# Access Compliance Report

## Public Rights-of-Way

Intersection ID: 47396	Main Street: FLAT_RIVER_DR	Cross Street: KENBROOKE_DR	Location: E
ADA ID: 70E1ADF8C472	Ramp Type: Perp	Initial Pass/Fail: Fail	Overall Compliance: No
			Severity Score: 26.25

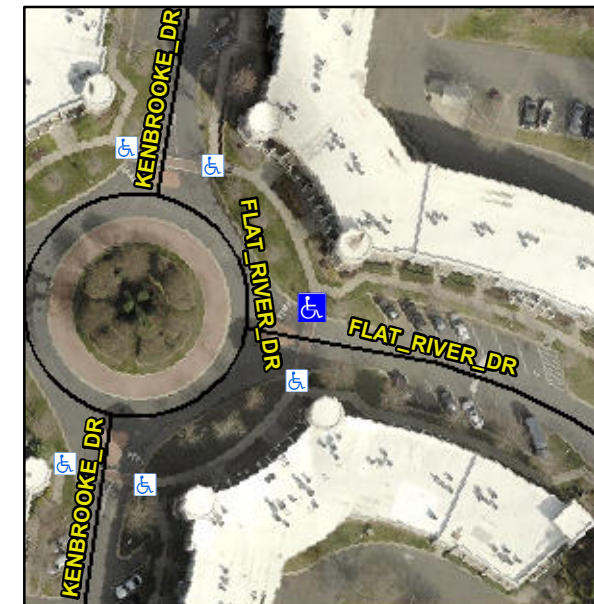
**R304.2.2, R304.5.3**

Compliance	Description	Data	Compliance	Description	Data
N/A	Ramp Length (in)	51.5	No	Ramp Slope (%)	12.7
Yes	Ramp Width (in)	48.0	No	Ramp XSlope (%)	2.4
N/A	Flare Type LT	N/A	N/A	Flare Type RT	N/A
N/A	Flare Slope LT (%)	N/A	N/A	Flare Slope RT (%)	N/A
N/A	Flare Traversable LT?	N/A	N/A	Flare Traversable RT?	N/A
N/A	Landing Length (in)	N/A	N/A	DWS Provided?	N/A
N/A	Landing Width (in)	N/A	N/A	DWS Contrast?	N/A
N/A	Landing Slope (%)	N/A	N/A	DWS Length (in)	N/A
N/A	Landing X Slope (%)	N/A	N/A	DWS Full Width?	N/A
N/A	Landing Curb? (Y/N)	N/A	N/A	DWS Offset (in)	N/A
N/A	Shared Landing?	N/A			
N/A	Gutter Ponding?	N/A	N/A	Gutter Slope (%)	N/A
N/A	Gutter Lip Ht (in)	N/A	N/A	Gutter X Slope (%)	N/A
N/A	Painted X Walk1?	Yes	N/A	Painted X Walk2?	N/A
	X Walk 1 Direction	To S		X Walk 2 Direction	N/A
N/A	X Walk 1 Width (in)	51.0	N/A	X Walk 2 Width (in)	N/A
	X Walk 1 Slope (%)	7.3		X Walk 2 Slope (%)	N/A
	X Walk 1 X Slope (%)	0.3		X Walk 2 X Slope (%)	N/A

**Remove & Replace Entire Ramp.**
